Access Compliance Report

Public Rights-of-Way (Curb Ramps)

Intersection ID: 3109	Main Street: ASHBURTON_DR	Cross Street: WALDEN_RIDGE_DR	Location: W
ADA ID: 46BF8F92F0AD	Ramp Type: Perp	Initial Pass/Fail: Fail	Overall Compliance: No
Severity Score: 22.5			
Codes/Mitigation Info/Possible Solution		Field Measurements/Component Compliance

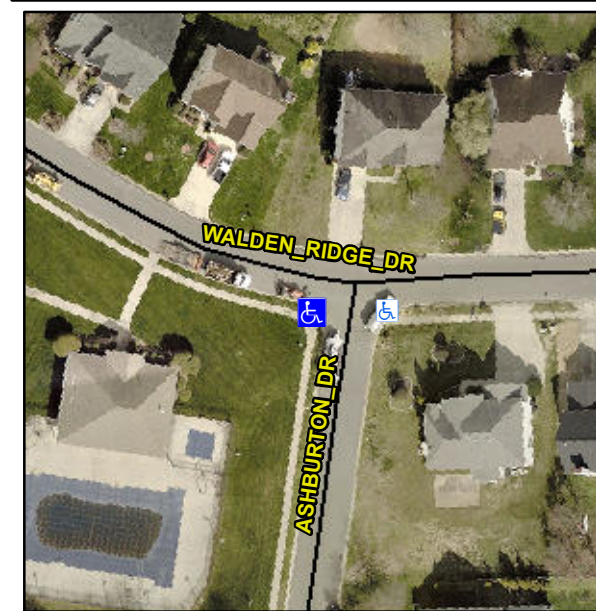
R304.5.1, R304.2.2, R304.5.3

Compliance	Description	Data	Compliance	Description	Data
N/A	Ramp Length (in)	40.0	No	Ramp Slope (%)	11.7
No	Ramp Width (in)	38.0	No	Ramp XSlope (%)	3.5
N/A	Flare Type LT	N/A	N/A	Flare Type RT	N/A
N/A	Flare Slope LT (%)	N/A	N/A	Flare Slope RT (%)	N/A
N/A	Flare Traversable LT?	N/A	N/A	Flare Traversable RT?	N/A
N/A	Landing Length (in)	N/A	N/A	DWS Provided?	N/A
N/A	Landing Width (in)	N/A	N/A	DWS Contrast?	N/A
N/A	Landing Slope (%)	N/A	N/A	DWS Length (in)	N/A
N/A	Landing X Slope (%)	N/A	N/A	DWS Full Width?	N/A
N/A	Landing Curb? (Y/N)	N/A	N/A	DWS Offset (in)	N/A
N/A	Shared Landing?	N/A			
N/A	Gutter Ponding?	N/A	N/A	Gutter Slope (%)	N/A
N/A	Gutter Lip Ht (in)	N/A	N/A	Gutter X Slope (%)	N/A
N/A	Painted X Walk1?	No	N/A	Painted X Walk2?	N/A
	X Walk 1 Direction	To E		X Walk 2 Direction	N/A
N/A	X Walk 1 Width (in)	N/A	N/A	X Walk 2 Width (in)	N/A
	X Walk 1 Slope (%)	0.3		X Walk 2 Slope (%)	N/A
	X Walk 1 X Slope (%)	0.7		X Walk 2 X Slope (%)	N/A

Remove & Replace Entire Ramp.
